BIG ROCK POINT PLANT

AMENDMENT TO FACILITY OPERATING LICENSE

Amendment No. 76
License No. DPR-6

ATTACHMENT TO LICENSE AMENDMENT NO. 76

FIGURE 6.2-1

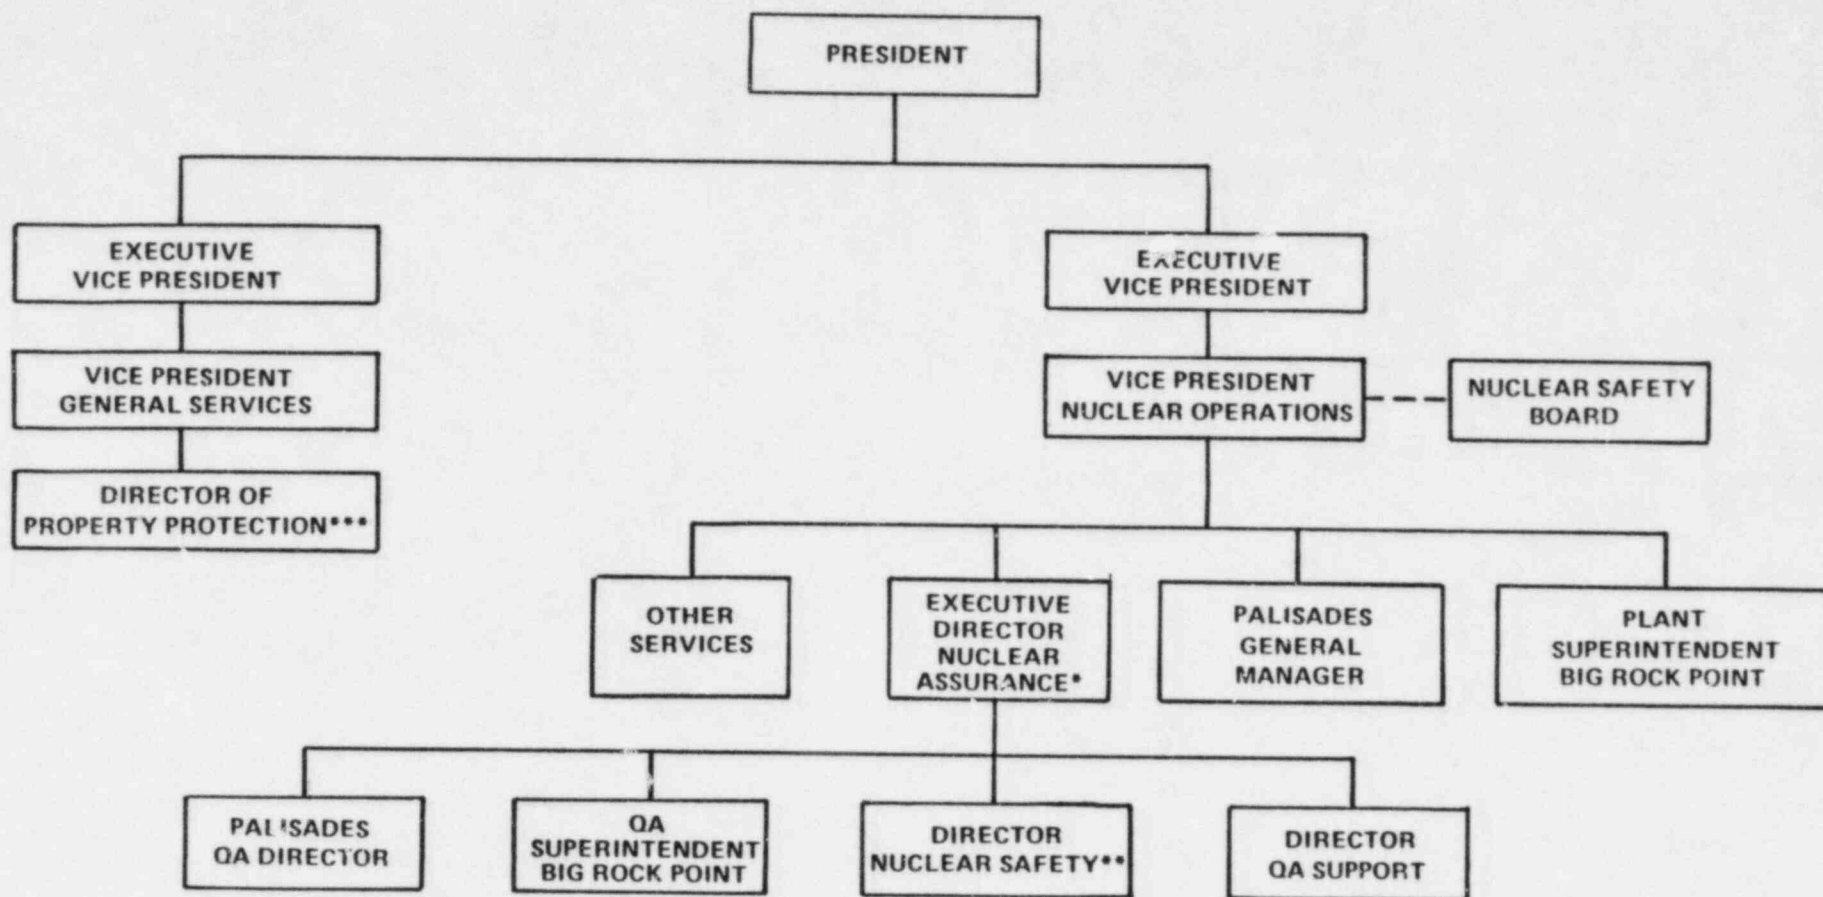
Revise Appendix A Technical Specifications by removing the pages identified below and inserting the enclosed pages. The revised pages are identified by the captioned amendment number and contain marginal lines indicating the area of change.
